# ADDENDUM NO. 1

**PROJECT NO:** STPSU-0220(256)  
**PROJECT DESCRIPTION:** INSTALLATION OF A ROUNDABOUT AT NORTH SECTION STREET/SCENIC 98 (VETERANS DR)/MAIN STREET  
**PROJECT OWNER:** CITY OF FAIRHOPE  
**OWNER REP / ENGINEER:** VOLKERT INC. / JORDAN STRINGFELLOW, P.E.  
**DATE OF ISSUE:** November 15, 2024  
**RECIPIENT:** Meeting Attendees and Plan Holders

STPSU PROJECT ROUNDABOUT INSTALLATION

**REVISED PLAN SHEETS**  
**NOVEMBER 15, 2024**

REV 1:  
REVISED 305A-057  
TO 305B-078; REVISED  
QTY FOR PAY ITEM  
610D-003; ADDED  
PAY ITEM 606A-009

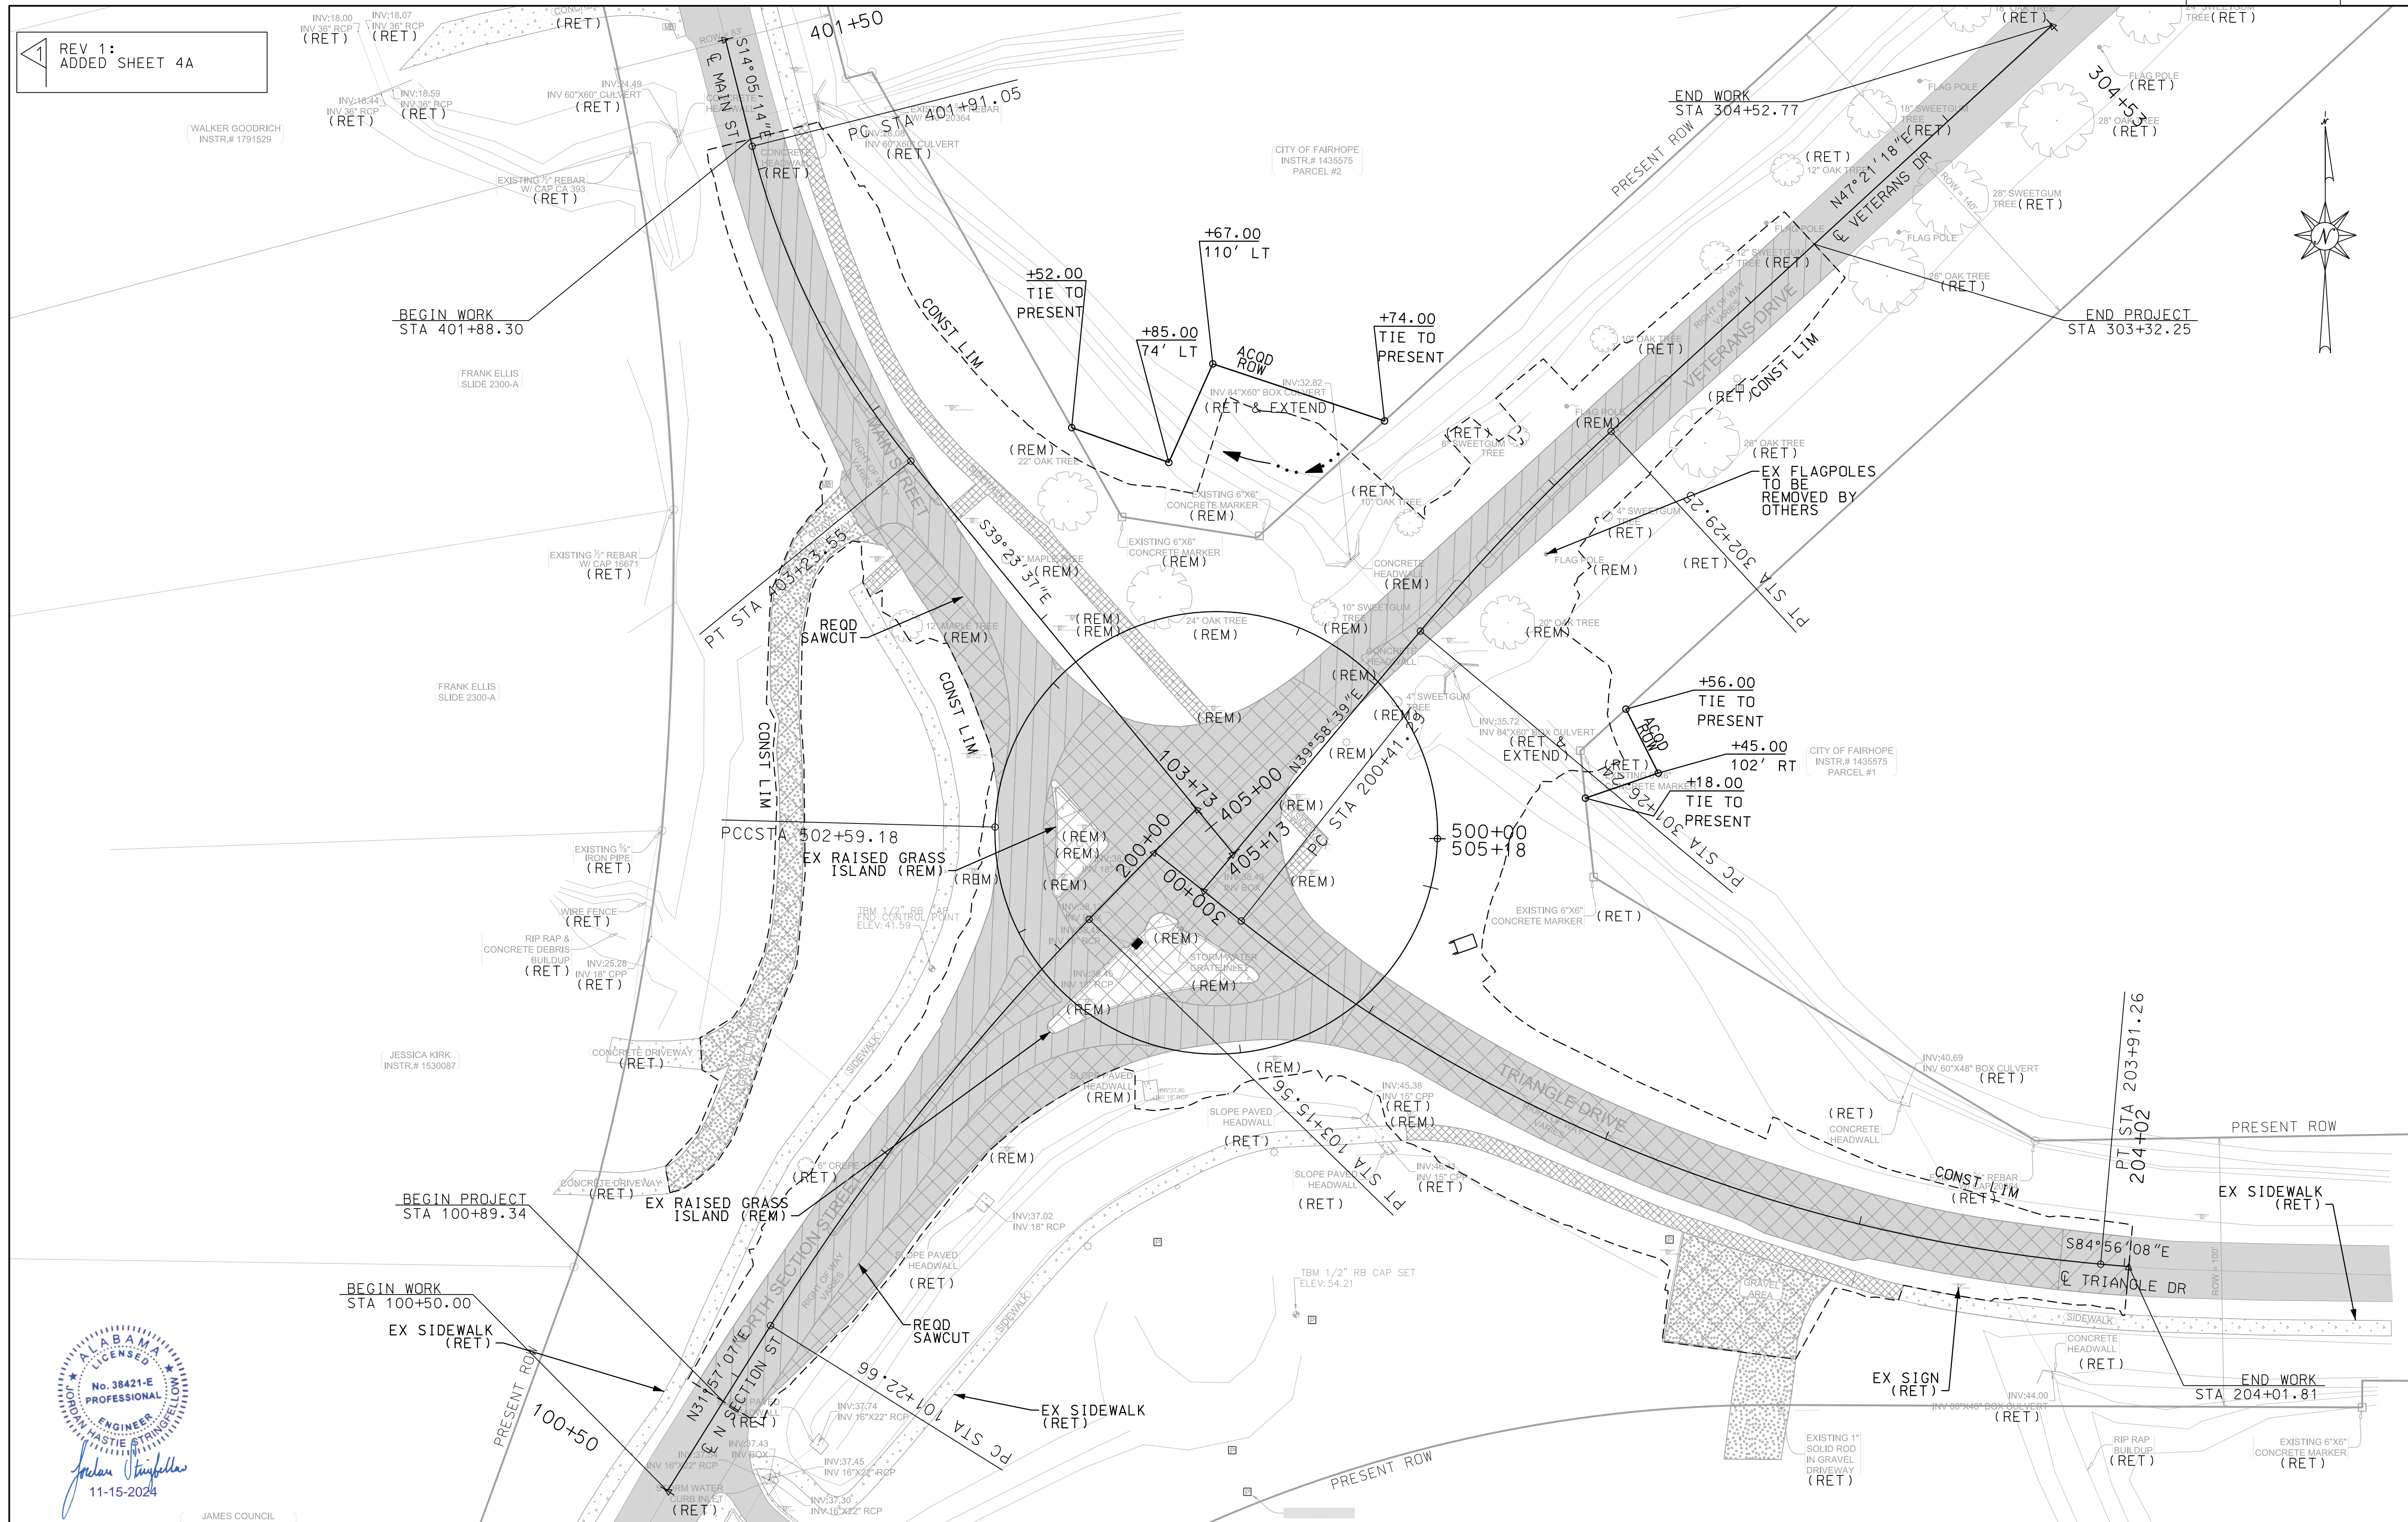
8. What is the backfill material requirement for the 2-foot of undercut below the culvert extension?

△ REV 1: REVISED QTY FOR FILTER BLANKET (GEOTEXTILE)

| STPSU-0220(256)      | 2024        | 20       |

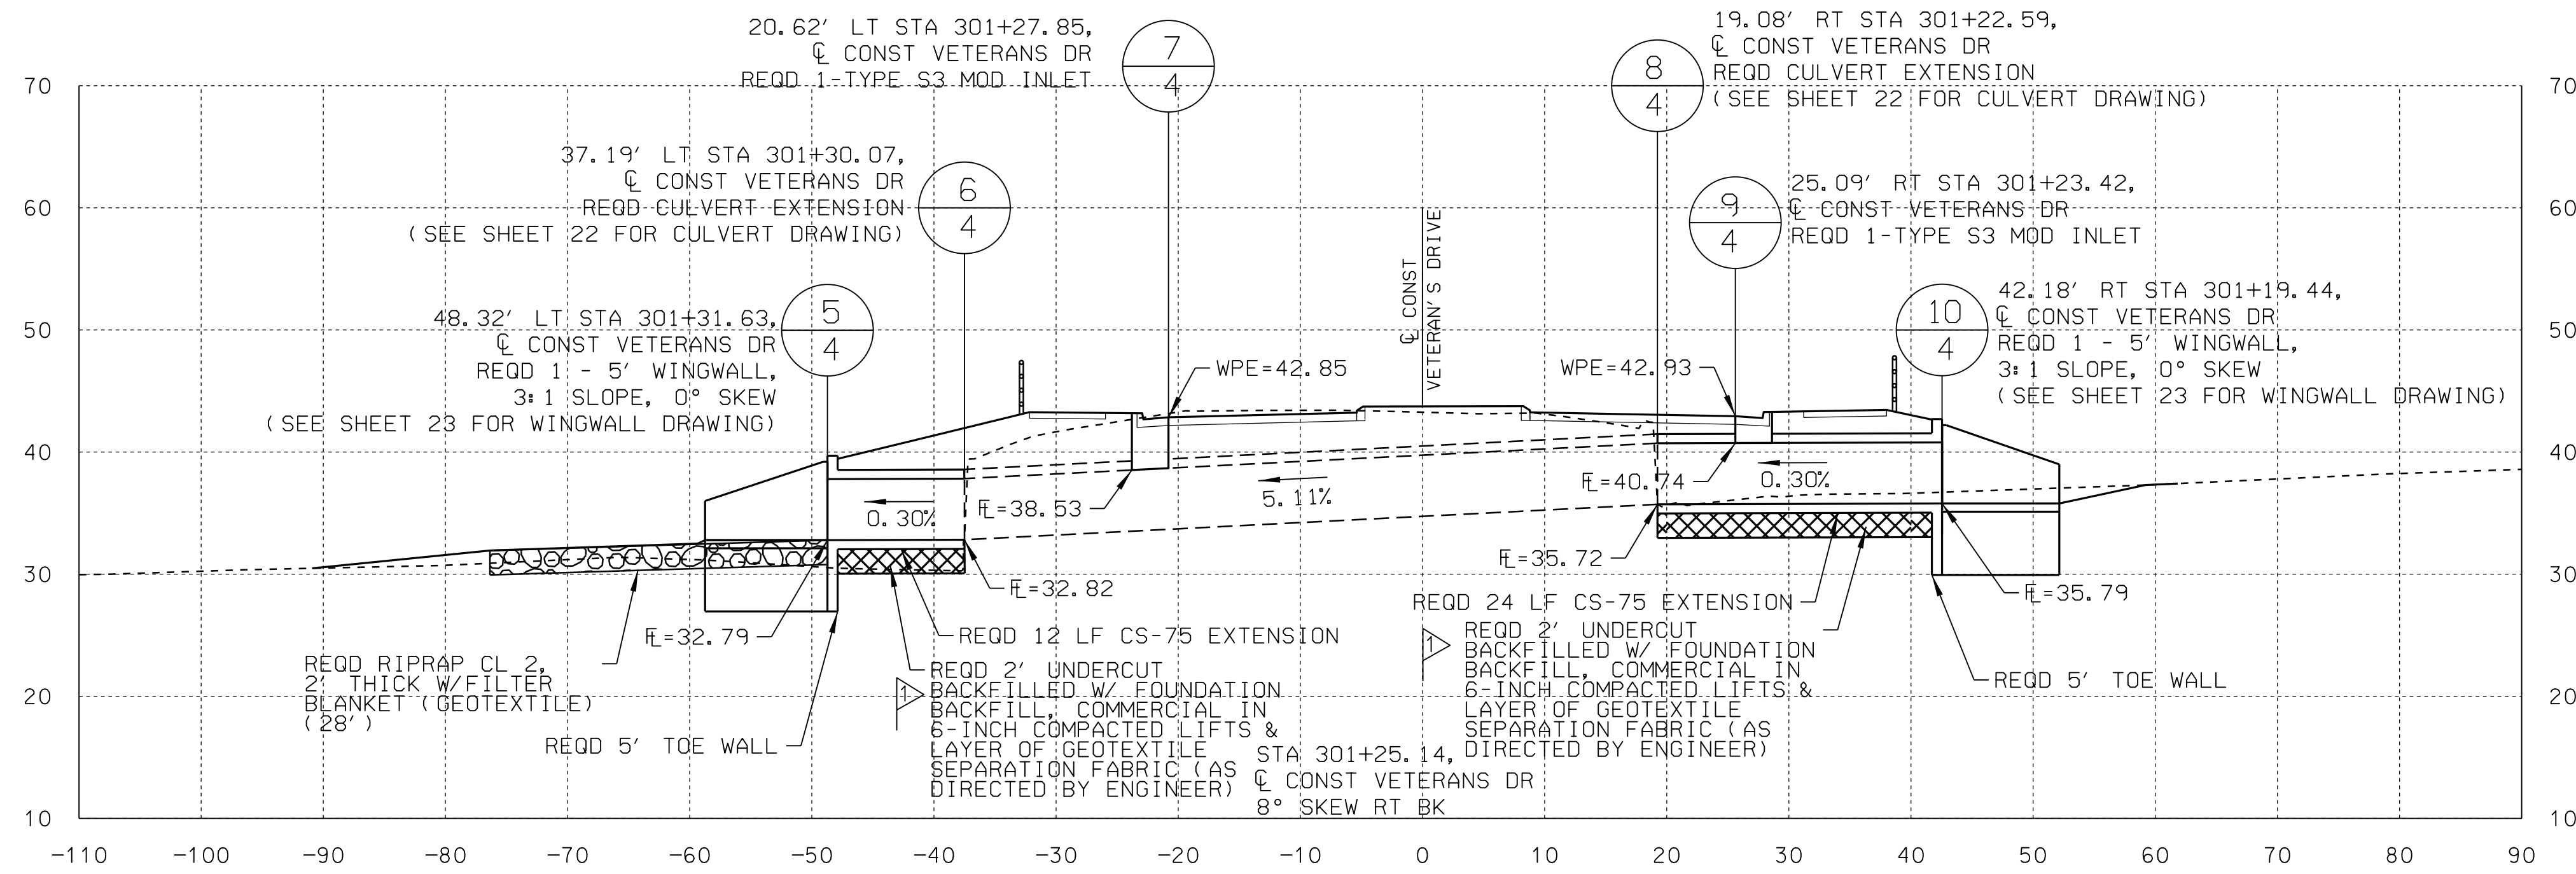
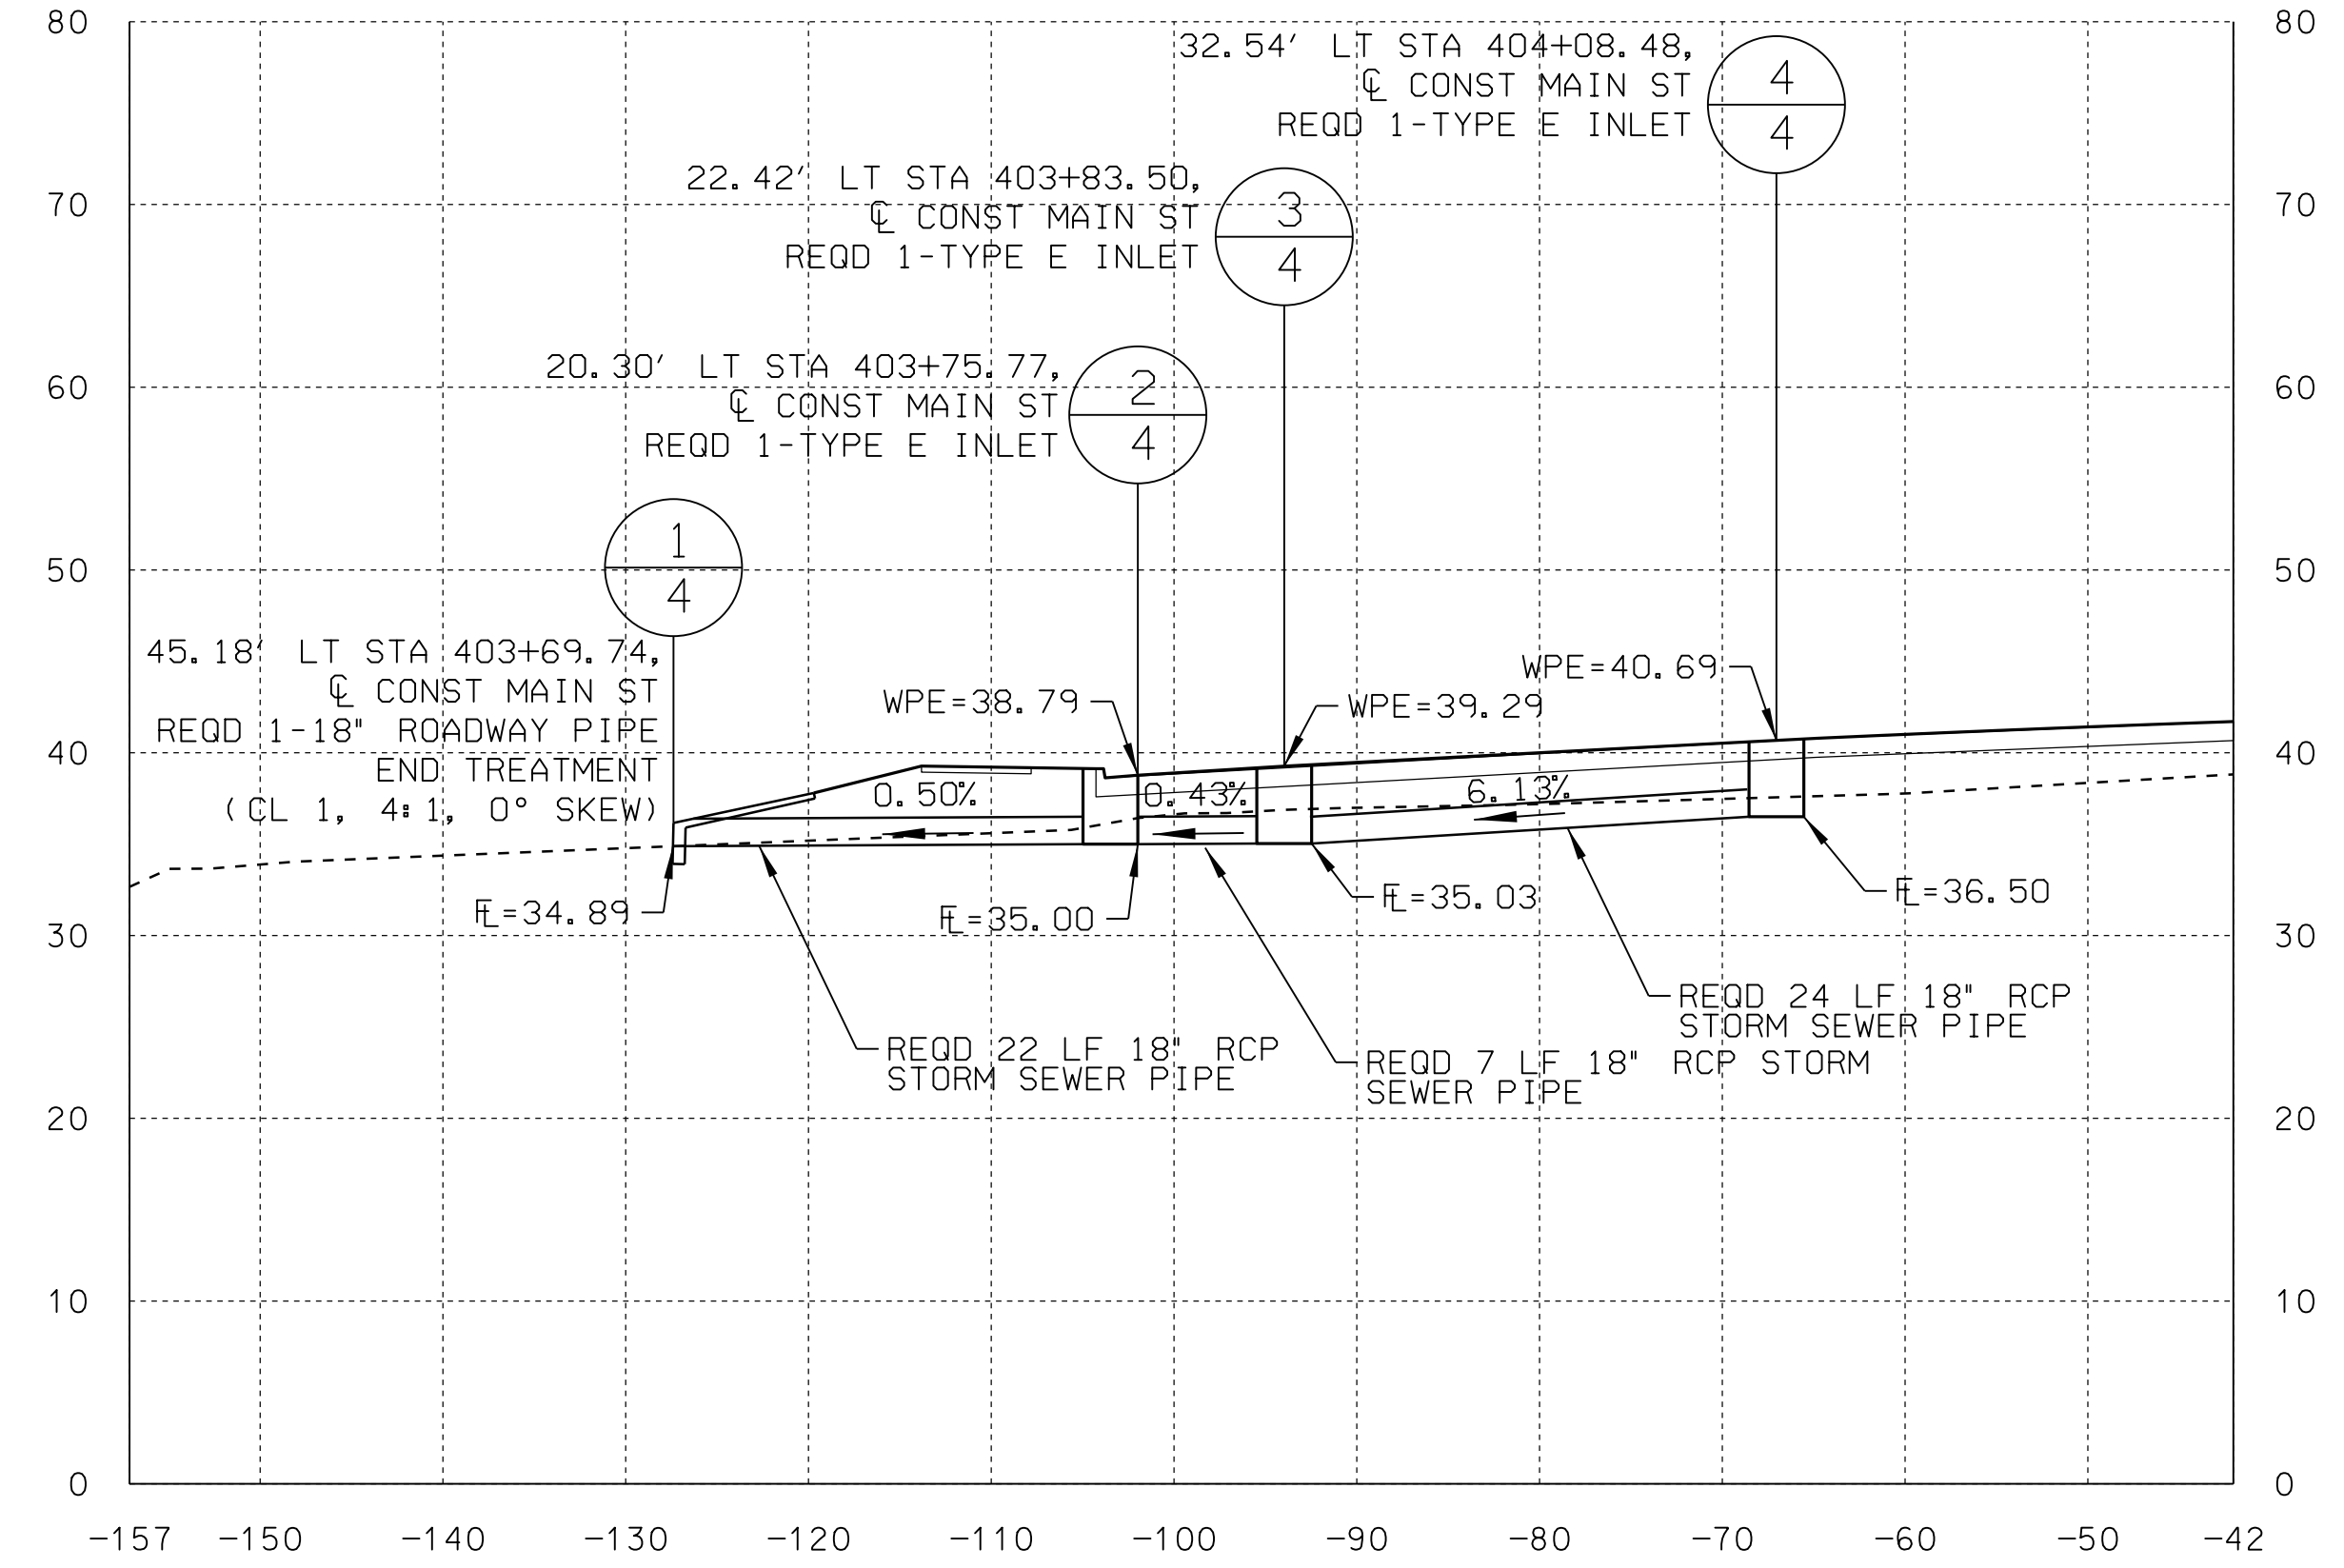
7. How tall is the toe wall for the required culvert extension?

**ANSWER:** The toe wall is 5-foot. See sheet 20 in the construction plans.

**ANSWER:** The backfill material shall be commercial foundation backfill in accordance with the 2022 Alabama Department of Transportation Standard Specifications for Highway Construction. The callout on sheet 20 has been updated to reflect this. Prior to backfilling, a layer of geotextile filter blanket shall be placed as directed by the Engineer.

REV 1:  
UPDATED DRAINAGE SECTION TO CALL FOR FOUNDATION BACKFILL, COMMERCIAL
